MSN 1790 (M)
Amendment 1

**Agreement Concerning Specific Stability
Requirements for Ro-Ro Passenger Ships
Undertaking Regular Scheduled International or
Domestic Voyages between European Ports**

**Notice to all Masters, Operators, Owners, Naval Architects, Shipbuilders,
Shiprepairers and Surveyors**

Summary

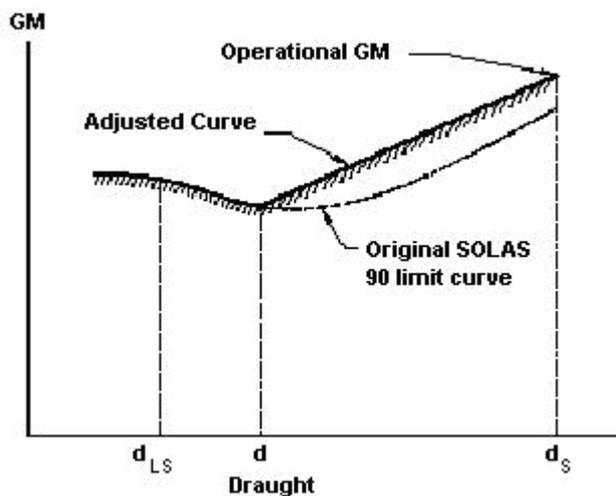
3.2.6. It is assumed that the ventilators of the damage compartment of the actual ship are adequate for unhindered flooding and movement of the flood water. However in trying to scale down the ventilating arrangements of the actual ship undesirable scale effects may be introduced. In order to ensure that these do not occur it is recommended to construct the ventilating arrangements to a larger scale than that of the model, ensuring that this does not affect the flow of water on the car deck.
